City of Alexandria, Virginia

MEMORANDUM

SUBJECT: PROPOSED CITY COMMENTS TO THE NATIONAL CAPITAL PLANNING COMMISSION ON PROPOSED BRAC- 133 AT THE MARK CENTER SITE AND BUILDING DESIGN

**ISSUE:** City comments to the National Capital Planning Commission (NCPC) regarding the final approval of the site layout and building design for the BRAC -133 project at Mark Center.

Current Proposal

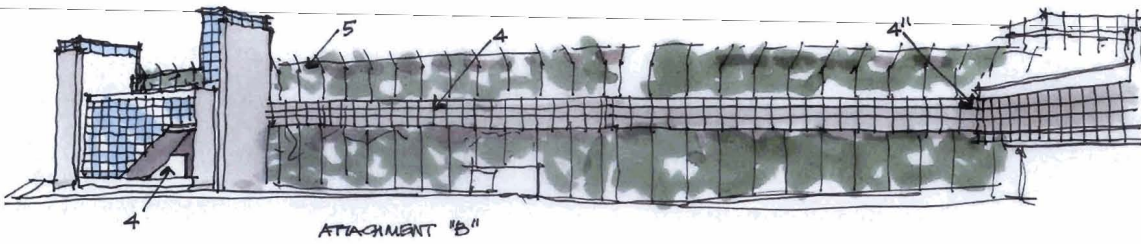
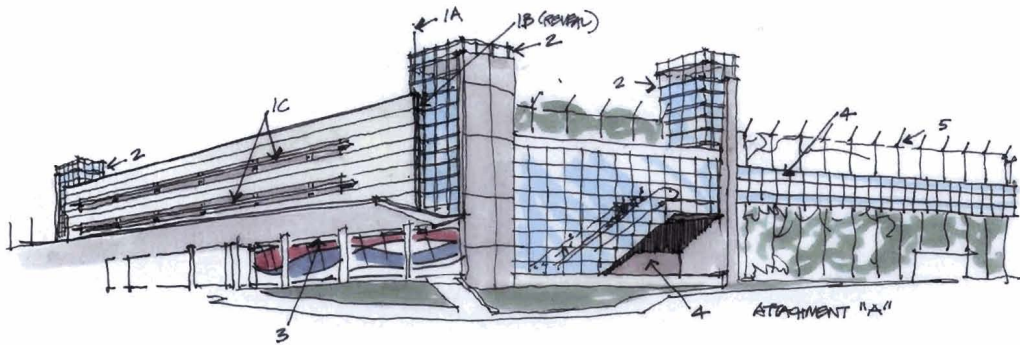
To accomplish these objectives, staff has been working towards utilizing a landscaped green-screen for portions of the building facade internal to the campus. The front façade facing Mark Center Drive is a greater challenge because it is a five-level parking structure facing Mark Center Drive. While the parking structure does have a small transit facility on the ground level, most of the ground level will be inactive use (garage) adjacent to the bus stops. Duke Realty, the project developer, and the Army have worked with the City to improve the design of the facility and are continuing this effort. To address the remaining design concerns, staff is recommending the following:

- Incorporation of public art on the ground level referencing aspects of the history or prehistory of the site. This art work should be required to be installed prior to completion of the building.
- The use of color and metal accents to enhance the horizontal expression and reduce the perceived length of the Mark Center Drive façade.
- Integration of signage into the overall design.
- Refinement of the stair towers and other pedestrian circulation elements.
- Incorporation of green elements into the roof design such as a trellis structure, landscaping, or comparable elements.

Staff Recommended Changes
